APPLICANT'S RESPONSES TO RELEVANT REPRESENTATIONS AND ADDITIONAL SUBMISSIONS

Drax Bioenergy with Carbon Capture and Storage

Document Reference Number: 8.3

PINS Reference: EN010120

DRAWING NUMBER
EN010120-PA-FCA-EC-30

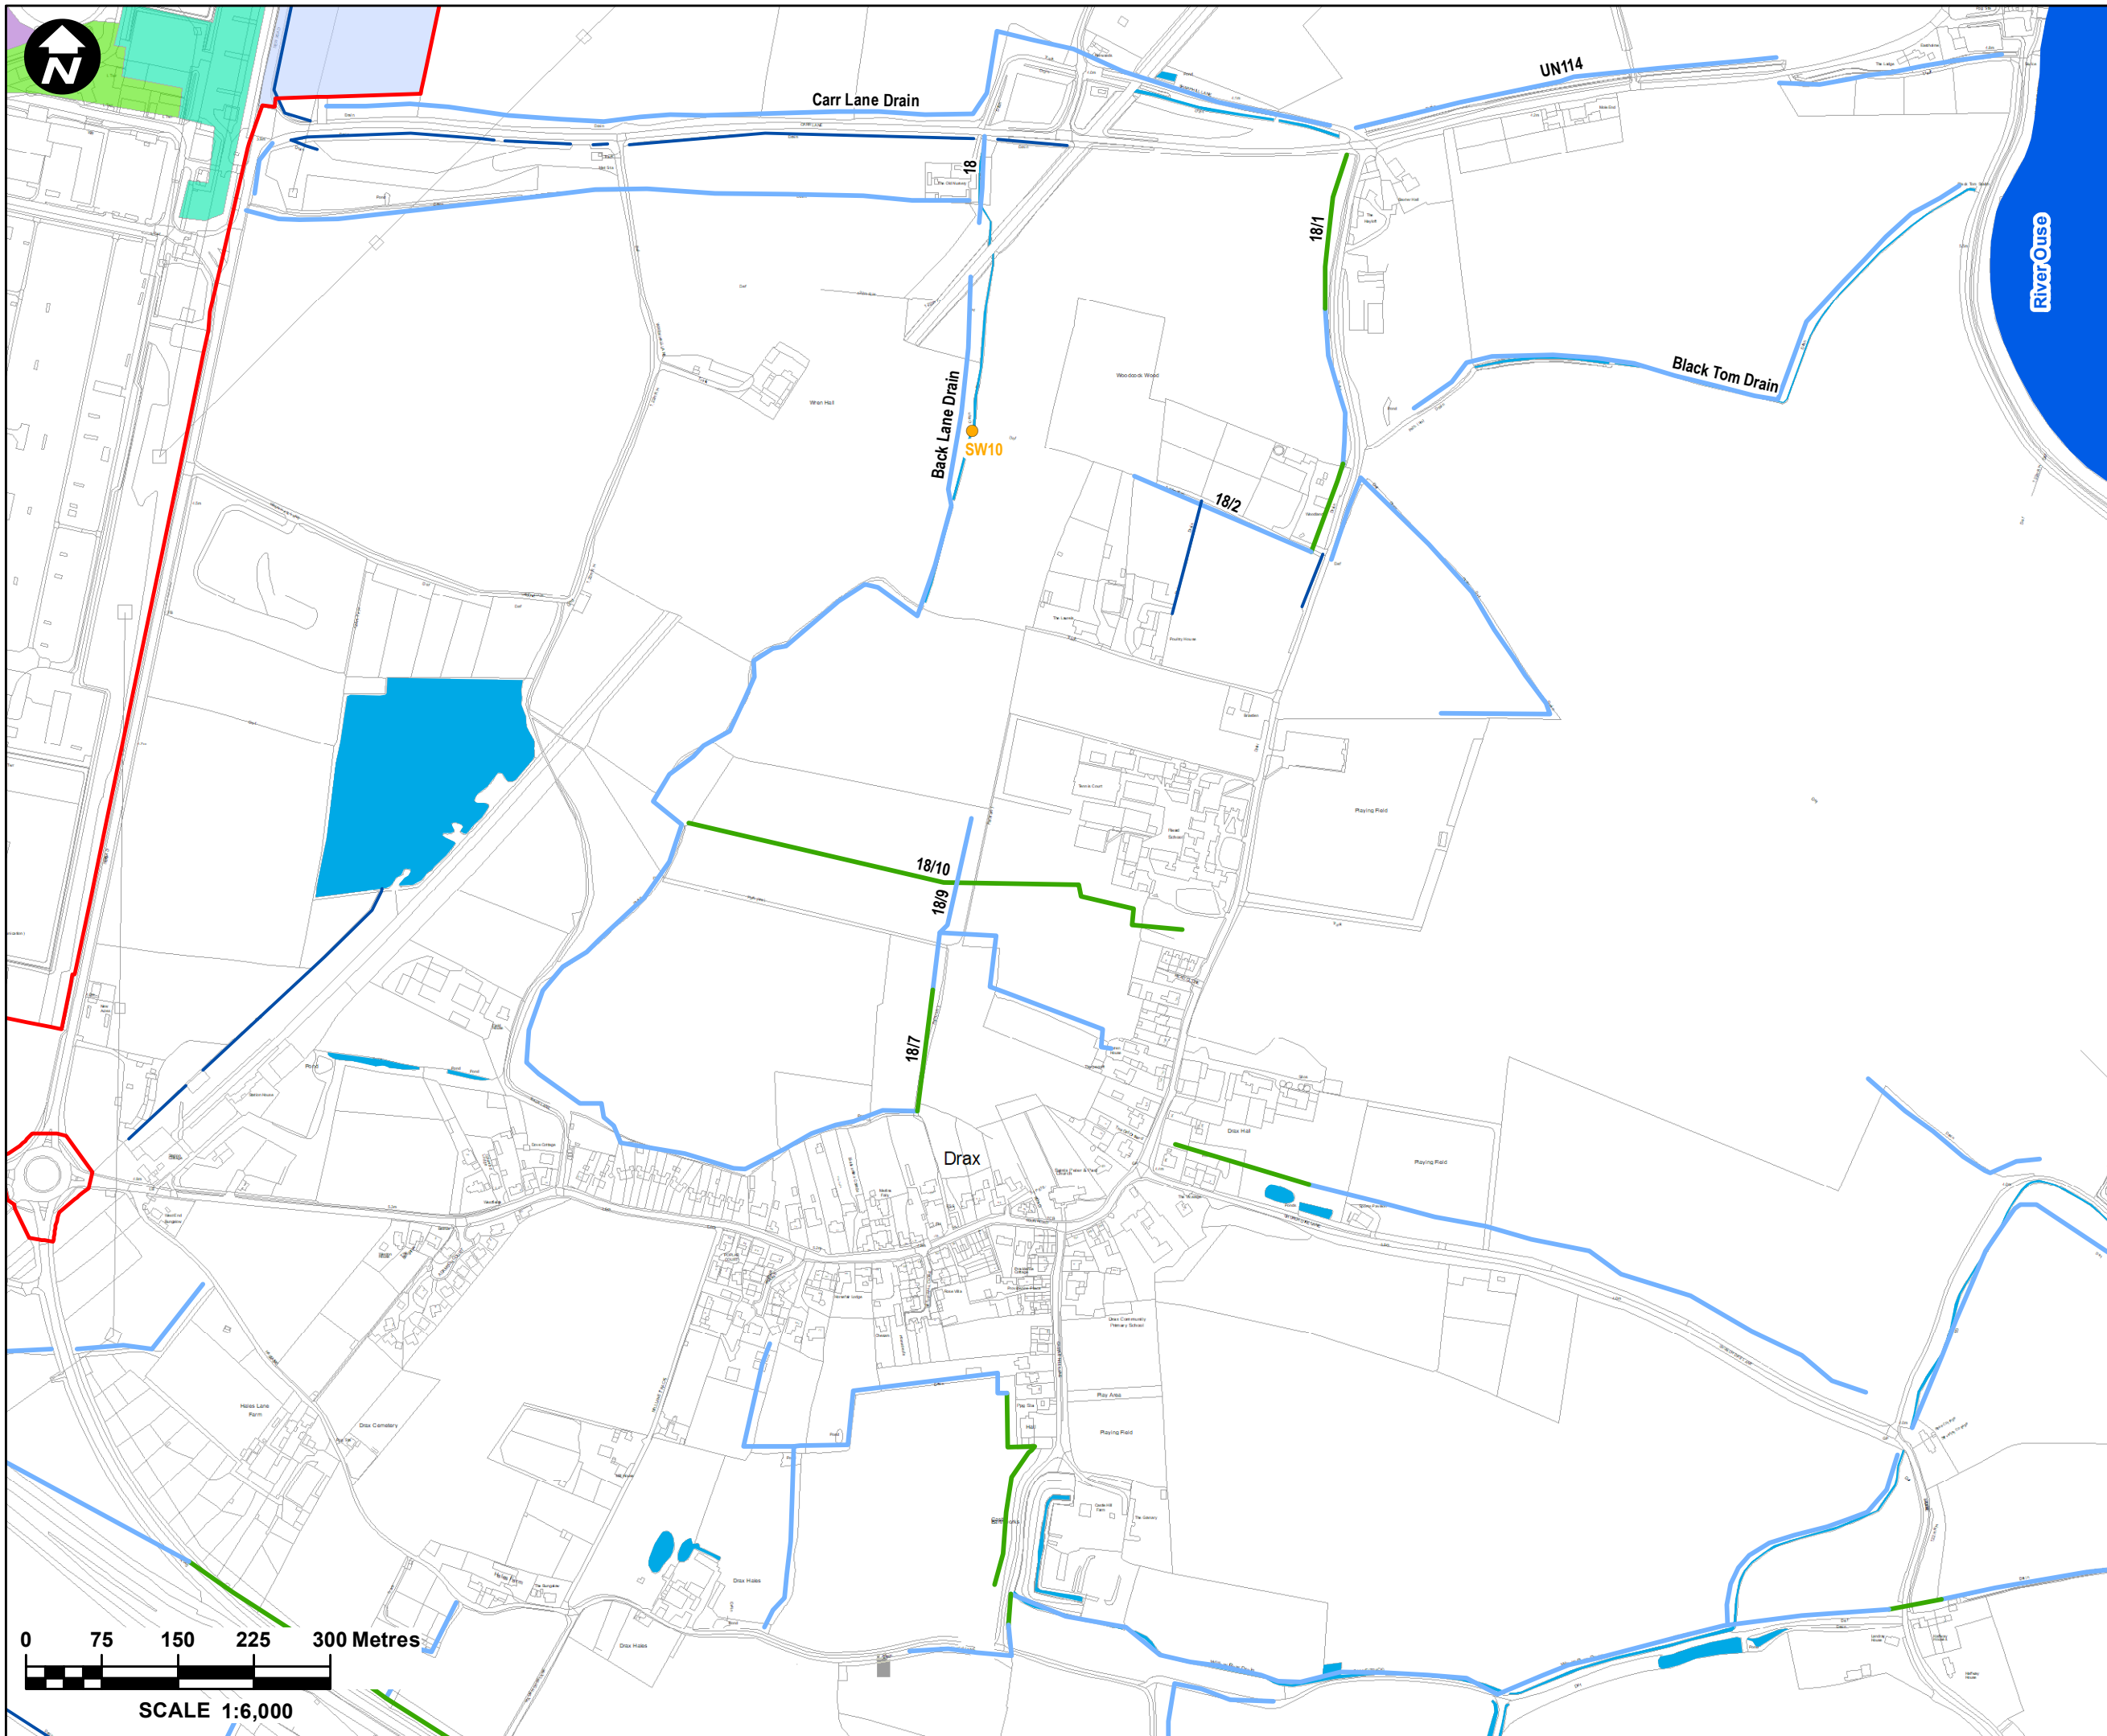
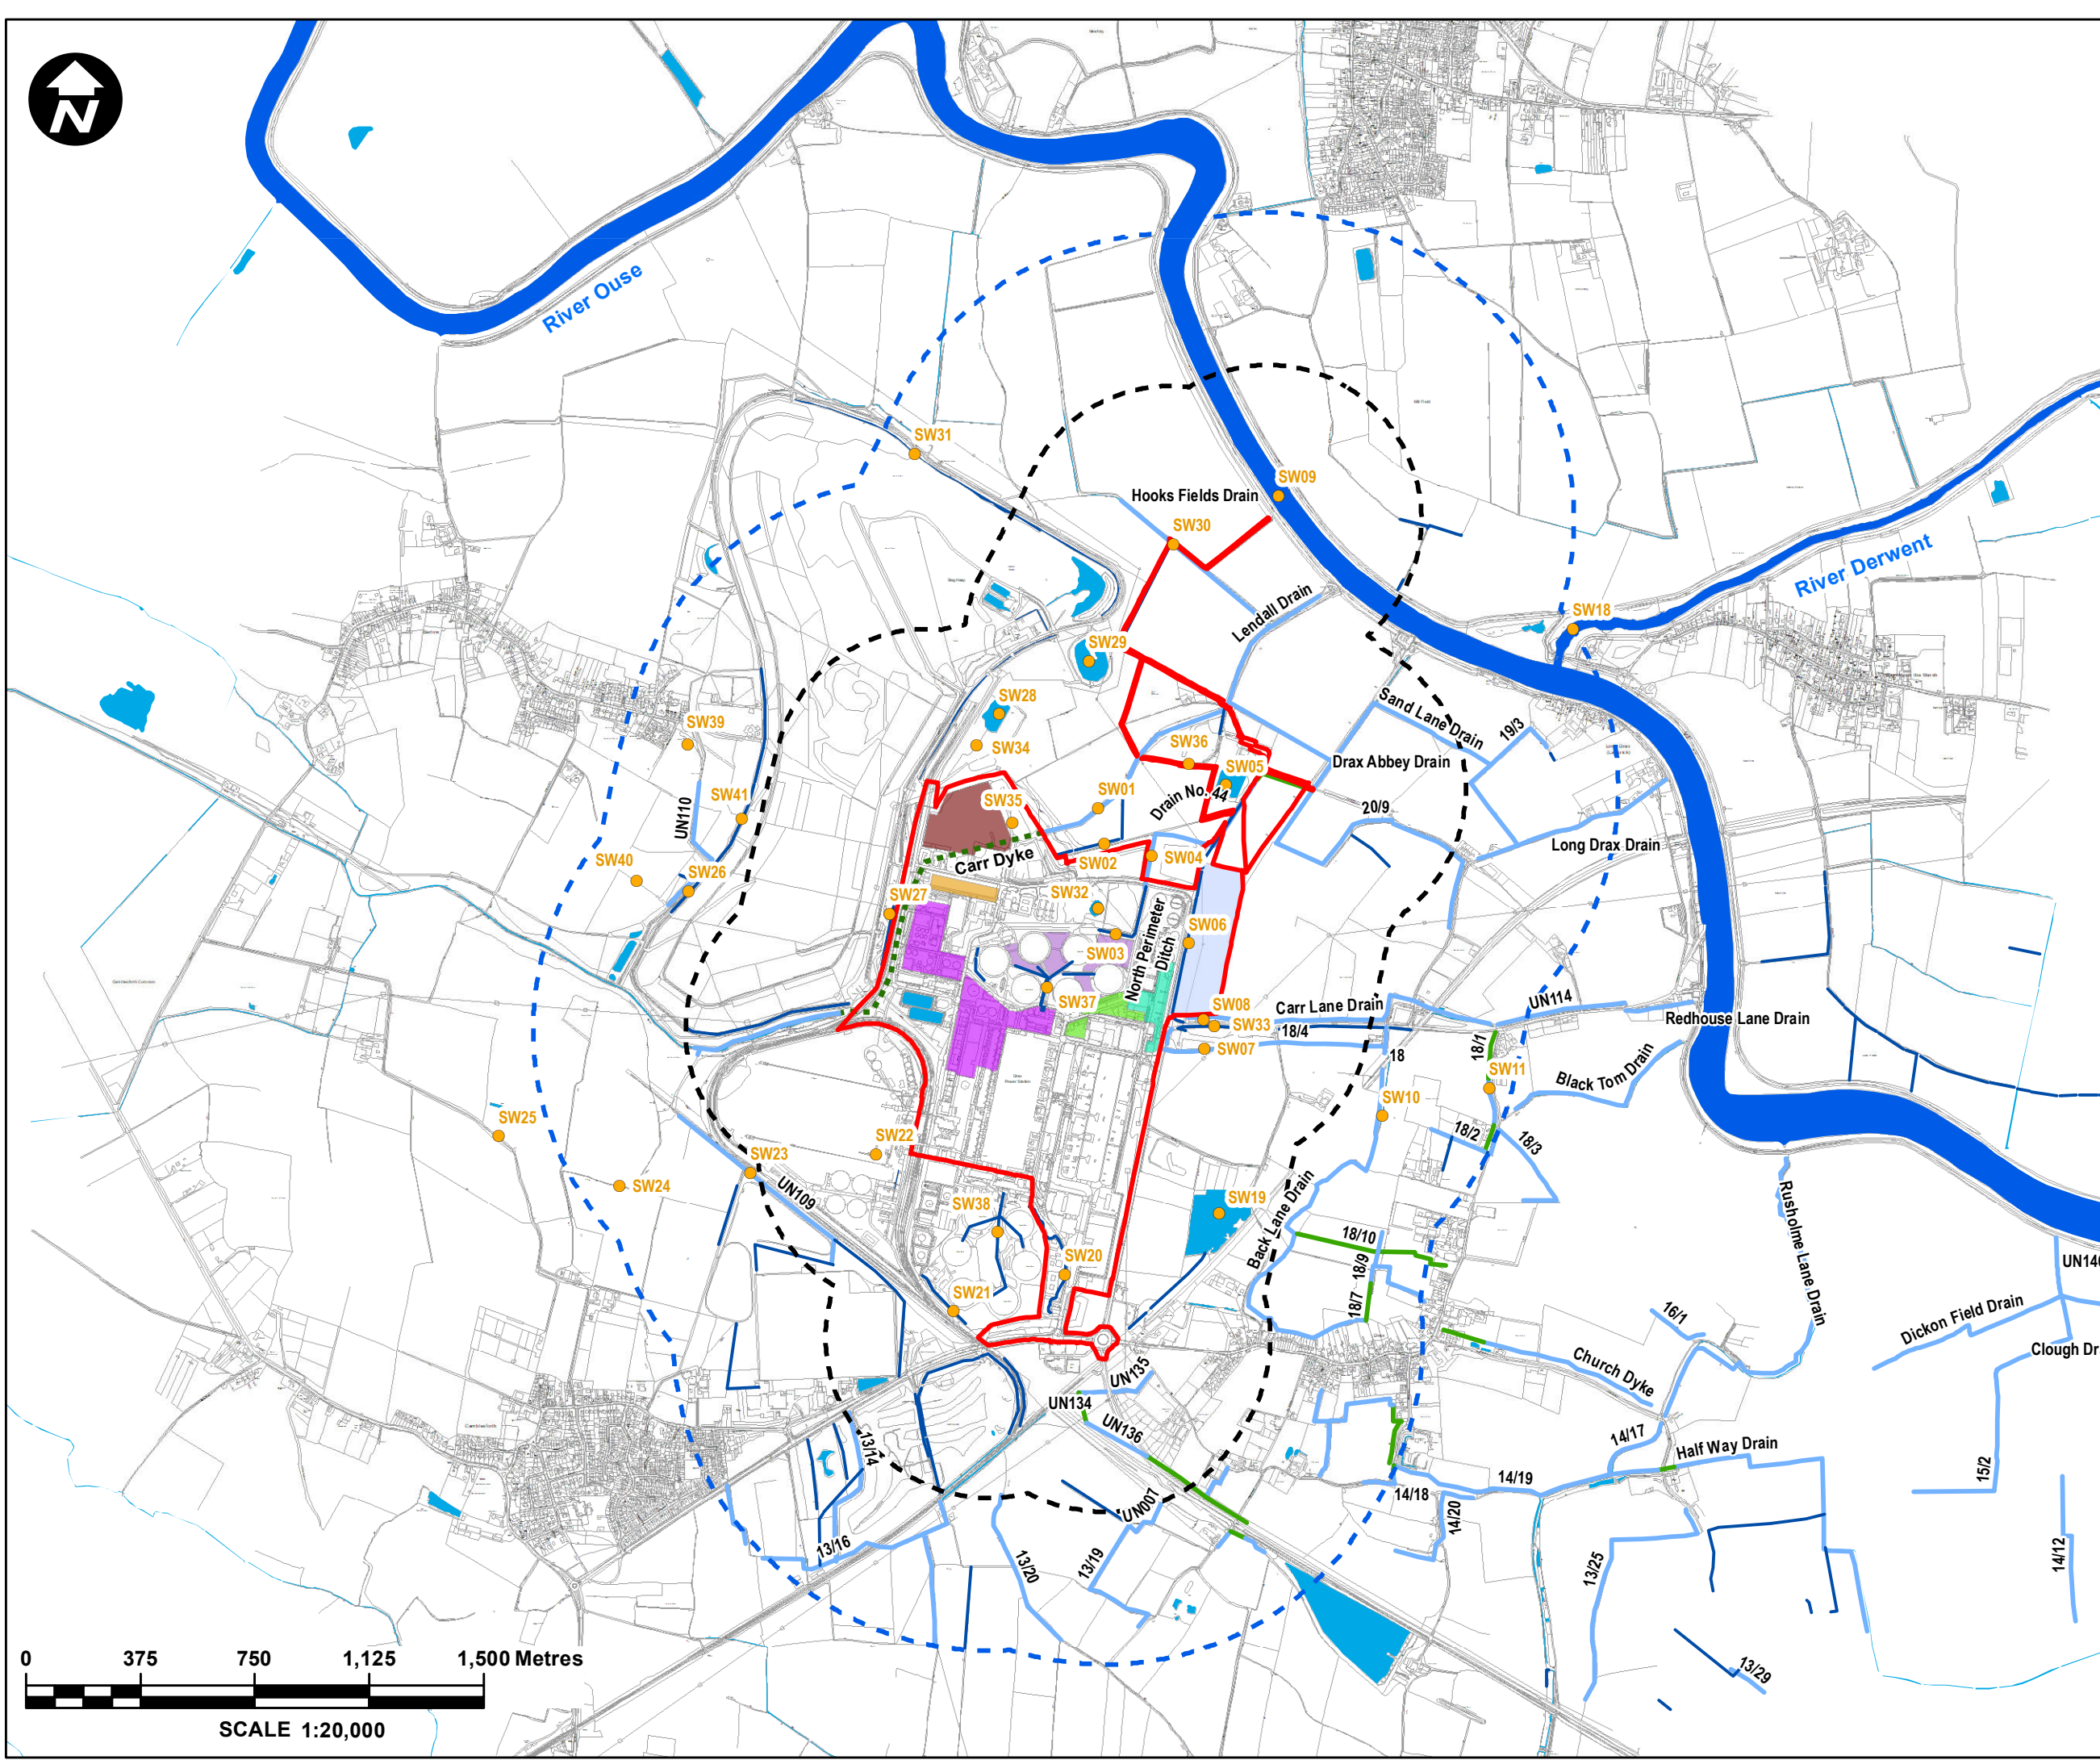
4.5	<p>Table 12.6 Surface Water Features within the study area that have the Potential to be Affected by the Proposed Scheme. Several of the ponds within this table which have a recorded presence of Great Crested Newt are not considered as 'sensitive receptor'. We disagree with this as they may be a habitat of the Great Crested Newt, which is a protected species and therefore a 'sensitive receptor'.</p> <p>This issue has also been raised in the Additional Submission Document Ref AS-040.</p>	<p>Whilst these ponds could be considered as a sensitive receptor as the presence of Great Crested Newt has been recorded / provide suitable habitat, they are not likely to be affected by the construction of the Proposed Scheme given that they are separated from the Proposed Scheme and Construction Areas, by an earth embankment, as shown in the image below, which would prevent any pollutants / contaminants which are accidentally released from the construction of the Proposed Scheme from reaching them.</p>

Figure 1. Illustration of modelled operating hours for the 4 x Units in the Full Load and Mid Merit Scenarios

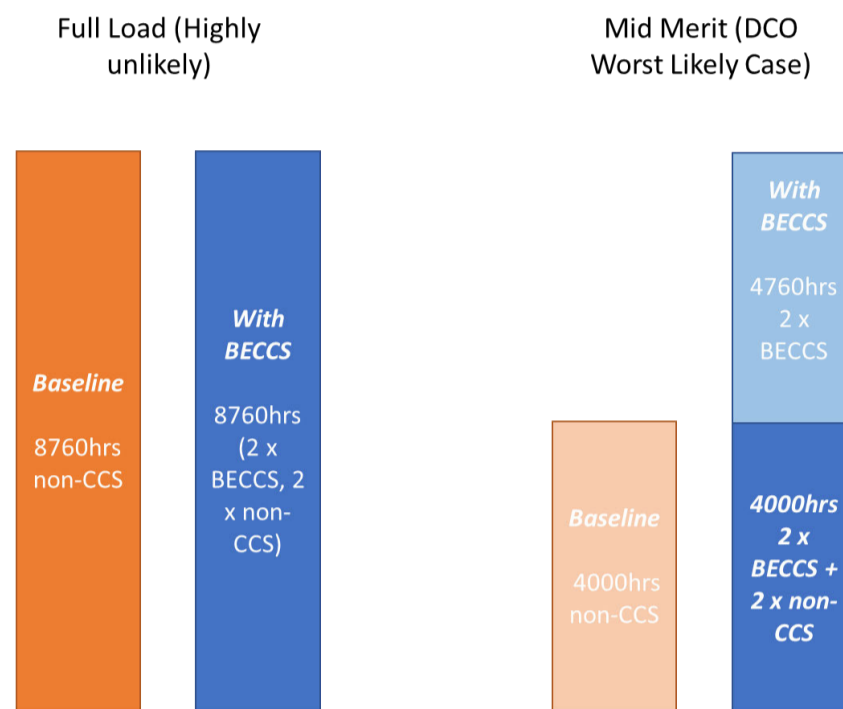
A standard assessment for a power station would be based on the full load operation of the power station both with and without any proposed changes. Since the Proposed Scheme involves fitting CCS to existing generation units, the Full Load operations involve 8760 hours of operation of 4 x units in both the baseline and With Scheme scenarios, with 2 of these units being BECCS units with the Proposed Scheme. This is illustrated in the left section of Figure 1.

With the Proposed Scheme and the relevant Government support mechanism (a Contract For Difference (CFD) which encompasses both power and carbon) in place it is highly likely that the operation of units with CCS will be more economically advantageous than operation of the non-CCS units since support on these current units will cease in 2027 and hence a future full load scenario is considered unlikely and a more intermittent operating regime would more likely result. To ensure a robust, worst-case assessment, a Mid-Merit scenario has been modelled as illustrated in the right-hand section of Figure 1. It involves 4 units (non-CCS) operating for 4000 hours in the baseline without the Proposed Scheme, and with the Proposed Scheme, the 2 x CCS units operating for 8760 hours (4000 h + 4760 h), and the 2 x non-CCS units operating for just 4000 of those 8760 hours.

Figure 2. Illustration of modelled air quality impacts for Full Load and Mid Merit Scenarios

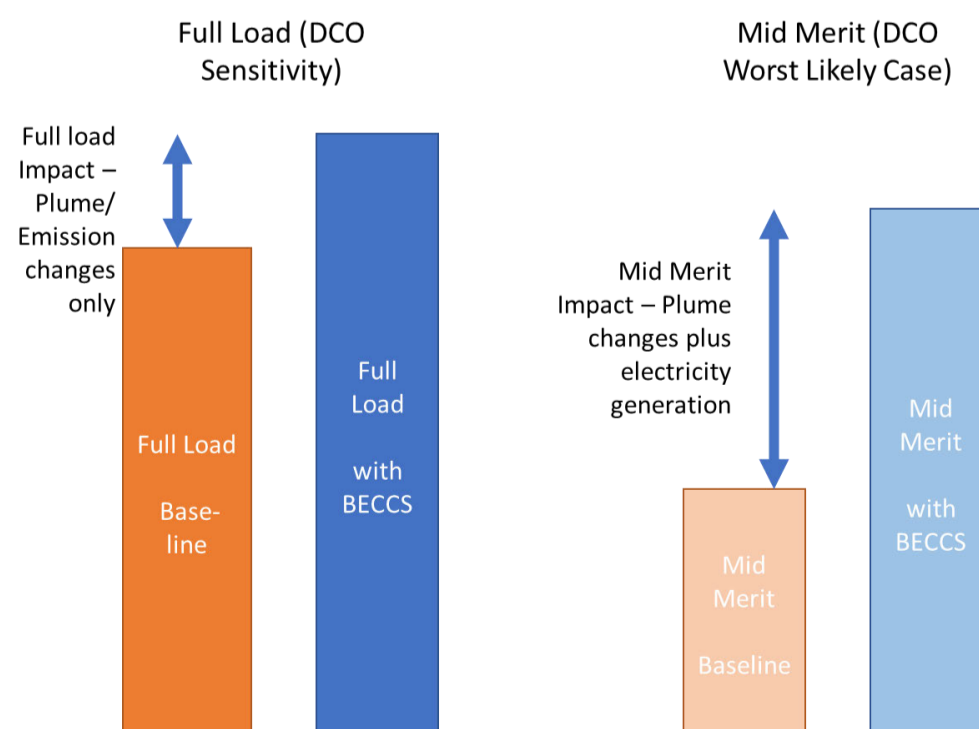
With an assessment based on Full Load operations, whilst the contribution of the plant to local concentrations of pollutants is maximised in both the Baseline and the With BECCS scenarios, the **impact** of BECCS is determined solely by the balance of the beneficial impacts of reduced pollutant concentrations and the adverse impacts of the change plume buoyancy (and a net slight disbenefit). This is illustrated in the left panel of Figure 2.

In the Mid Merit Case, the contribution of the plant to pollutant concentrations is reduced in comparison to the Full Load case, since the units are not all operating continuously in either Baseline or With BECCS scenarios. However, the **impact** of BECCS now includes both the plume/emission changes and the impacts of the likely increase in operating hours. This is illustrated in the right panel of Figure 2.

Figure 3. Illustration of modelled air quality impacts for Mid Merit Scenario without 3 unit operations (as modelled for ES, DCO Worst Likely Case) and with part use of 3 unit operations (Alternative Likely Case)

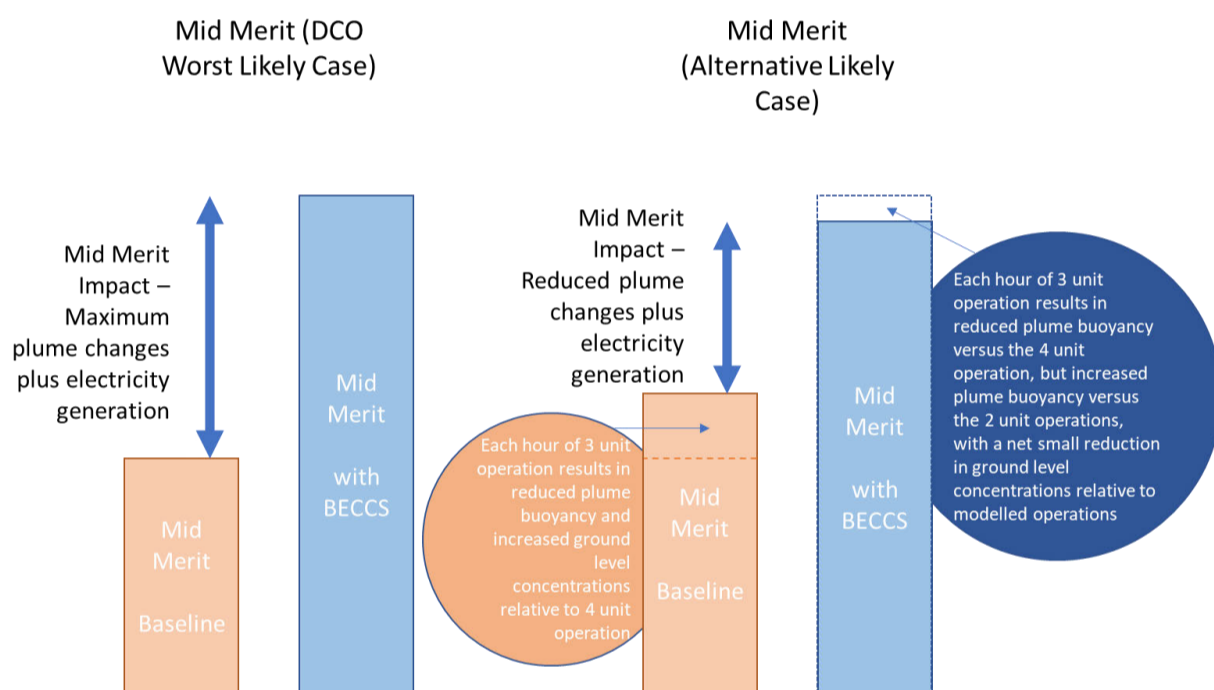
Such operations will lead to a reduction in the modelled impacts for the Mid Merit scenario. This is illustrated in Figure 3.

It must be noted that in the Baseline, moving any of the 4000 hrs for each unit operating from 4 to 3 unit operations (whilst maintaining the total operating hours/electricity production) results in **increased** process contribution at ground level because the buoyancy of the plume is reduced with 3 units in comparison to 4 units. For the with BECCS scenario, if you move from 4 unit operation to 3 unit operation, you must then replace one or more hours of 2 BECCS unit operation with 3 unit operation. Whilst the 4 to 3 unit operation change results in reduced plume buoyancy, the 2 to 3 unit change results in increased plume buoyancy, with the net effect that ground level concentrations decrease slightly. Overall the changes then result in a **reduced** impact in comparison to the modelled Mid Merit scenario.
